REZONING CASE NUMBER: 2018-077

**HAMILTON PARK
REZONING PLAN**
SOUTH-WEST CORNER OF THE INTERSECTION OF
STEELE CREEK ROAD AND HAMILTON ROAD
CHARLOTTE, NORTH CAROLINA 28273

**R2 DEVELOPMENT – HAMILTON PARK
REZONING PETITION 2018-077
RESPONSE LETTER – 09-26-2018**

PROJECT NO.	RTD-18000
FILENAME	RTD-18000-RZ1
CHECKED BY:	RMR
DRAWN BY:	JDL
SCALE:	1"=40'
DATE:	06-05-2018
SHEET NO.	RZ-1

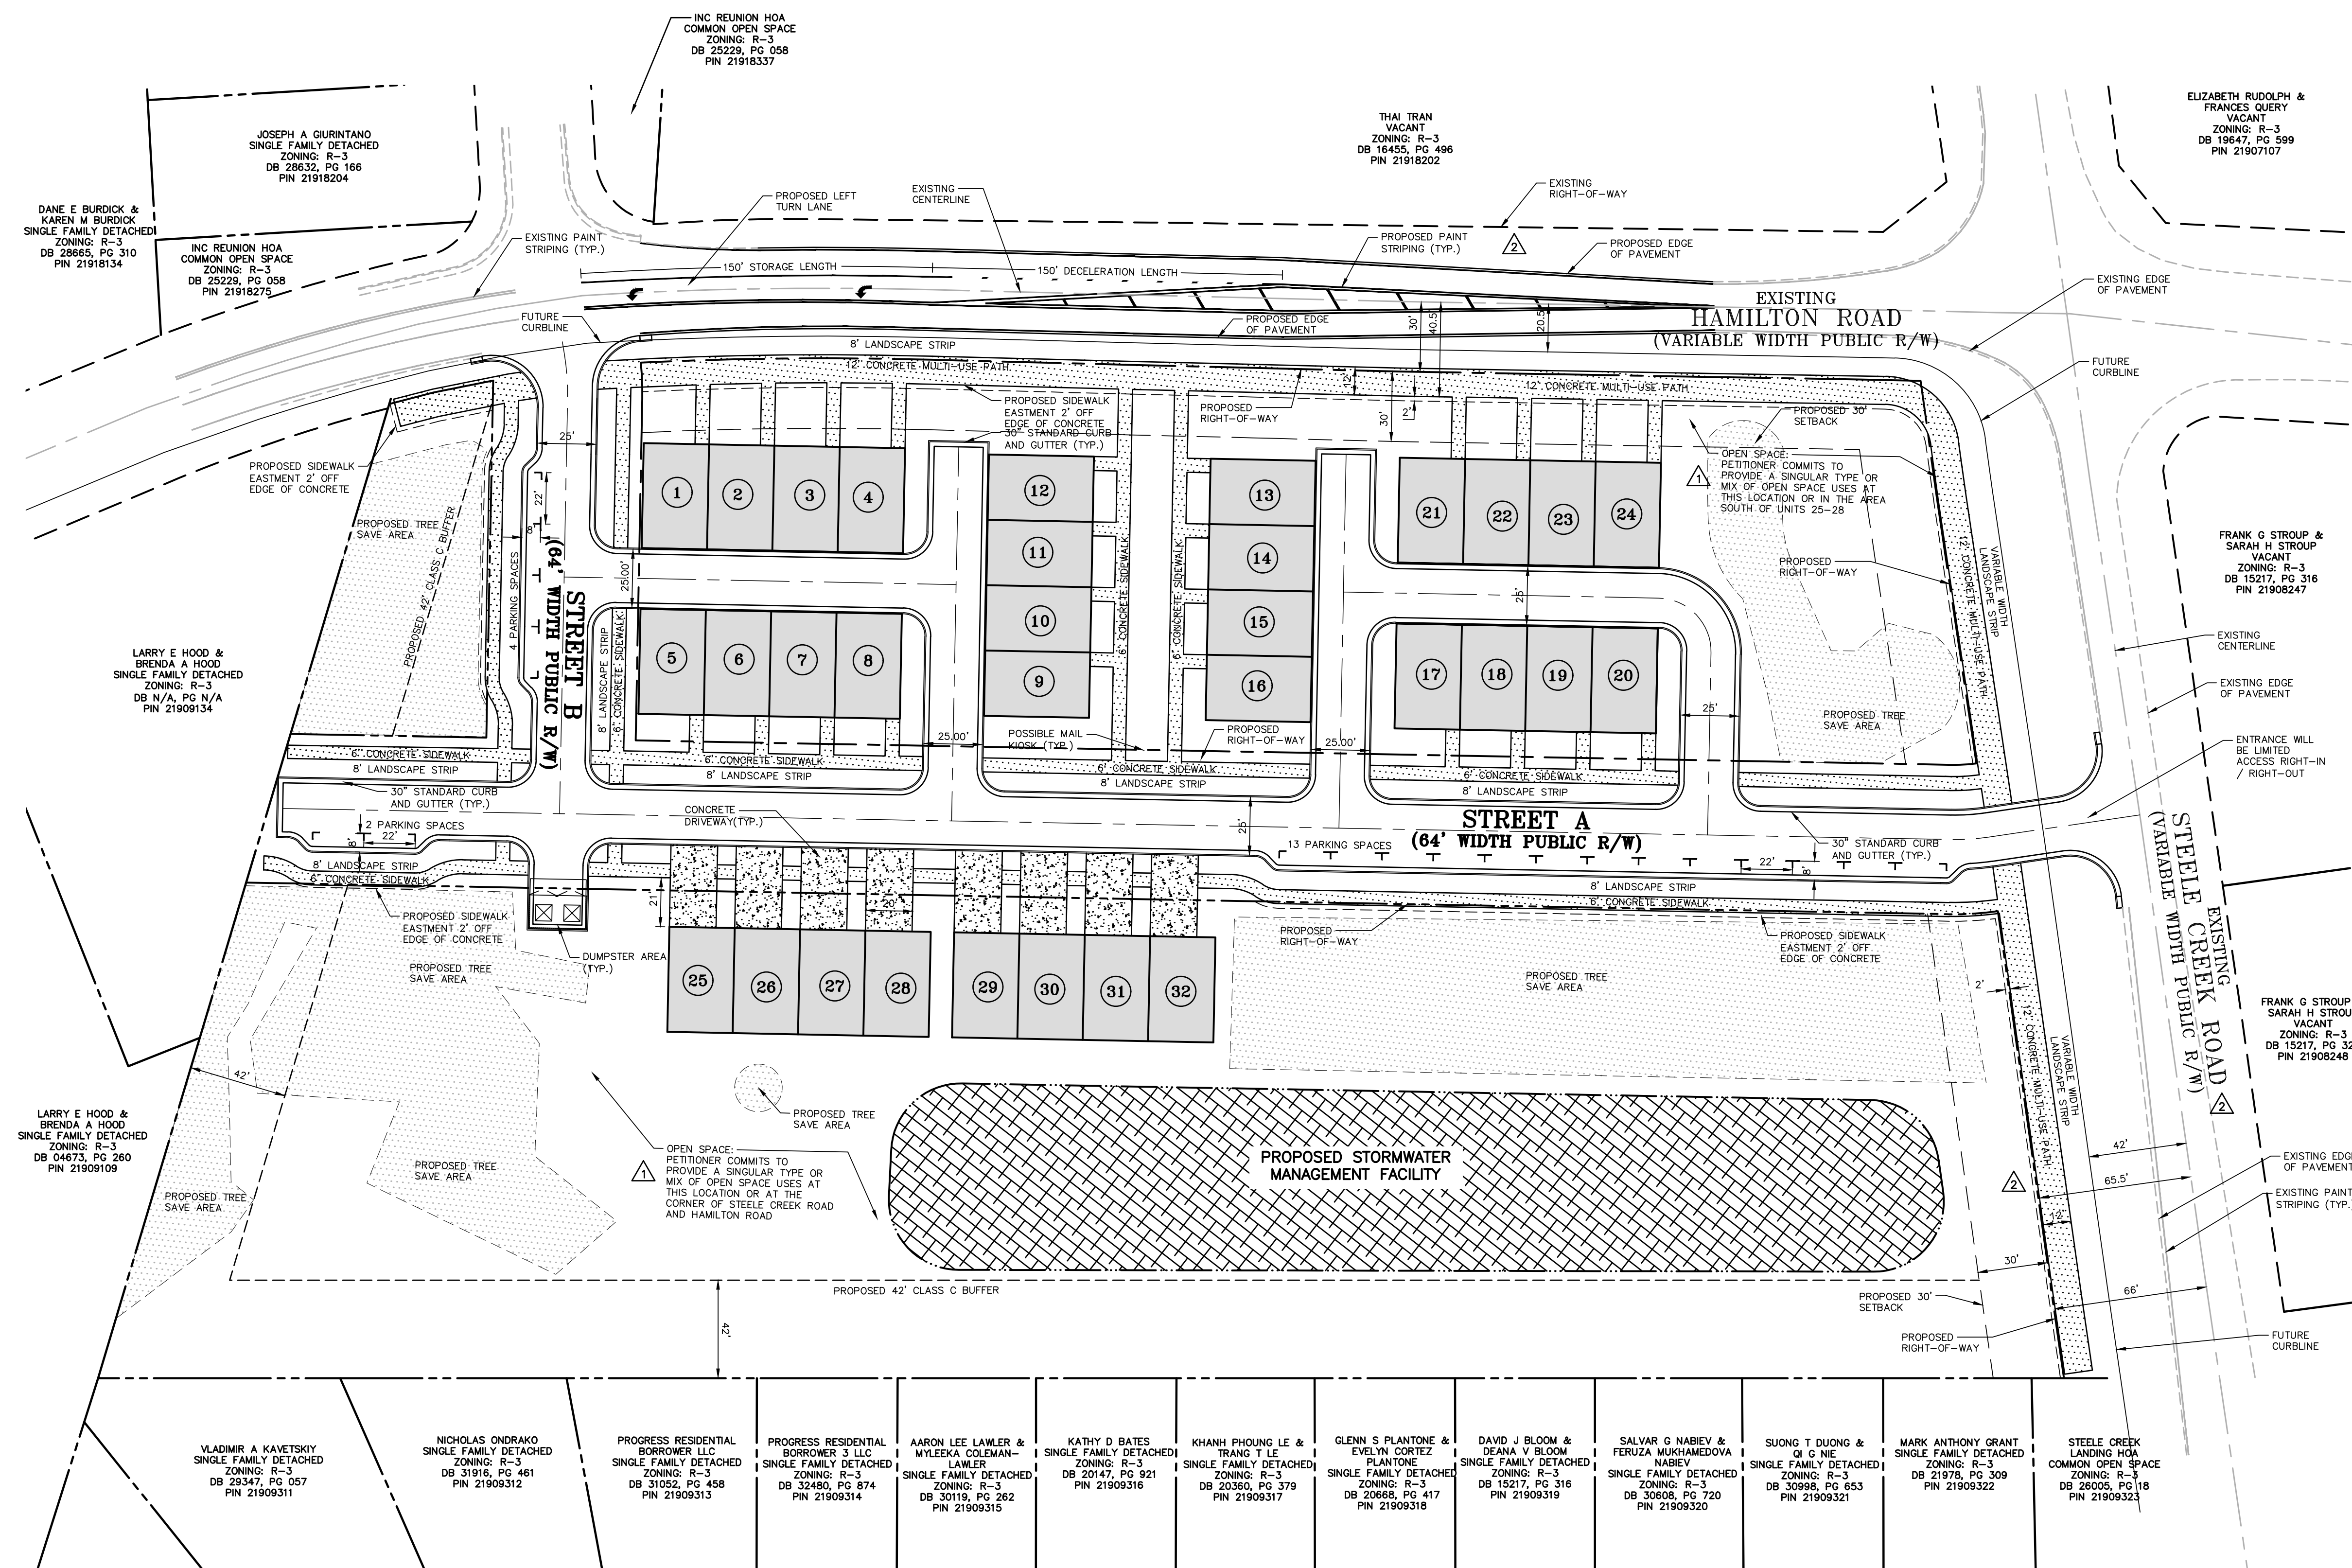
1. **Curbline** The proposed zoning district has a setback measured from back of the existing or proposed future curbline. The proposed cross section for the NCDOT widening project U-5766 has been updated. Based on the new cross section, the location of the future back-of-curb for:

- a. Steele Creek Road – 42 feet from centerline of the road (reduced from 53 feet)
- b. Hamilton Road – 20.5 feet from centerline of the road (reduced from 28 feet)

2. Revise the site plan to show:

- i. The back of multi-use path on Steele Creek Road located 65.5 feet from centerline of the road.
- ii. The back of multi-use path on Hamilton located 40.5 feet from centerline of the of the road.

4. The petitioner should revise the site plan to show the correct existing right-of-way on Hamilton Rd of 60 feet wide total, 30 feet from centerline of the road.

Response: Revised curblines from the centerlines of the roads have been provided:

- a. Steele Creek Road – 42 feet from centerline of the road
- b. Hamilton Road – 20.5 feet from centerline of the road

Response: The site plan has been revised to show:

- i. The back of multi-use path on Steele Creek Road located 65.5 feet from centerline of the road.
 - ii. The back of multi-use path on Hamilton located 40.5 feet from centerline of the of the road.
3. The right-of-way is shown incorrectly in the update site plan. Furthermore, the updated cross-section for the NCDOT widening project U-5766 has changed the right-of way. The petitioner should revise the site plan and conditional notes to show the dedication of right-of-way, fee simple, of 66 feet from centerline of Steele Creek Road (reduced from 75 feet).

Response: The ROW for Steele Creek Road has been revised to reflect the above.

Response: The ROW for Hamilton Road has been revised to reflect the above.
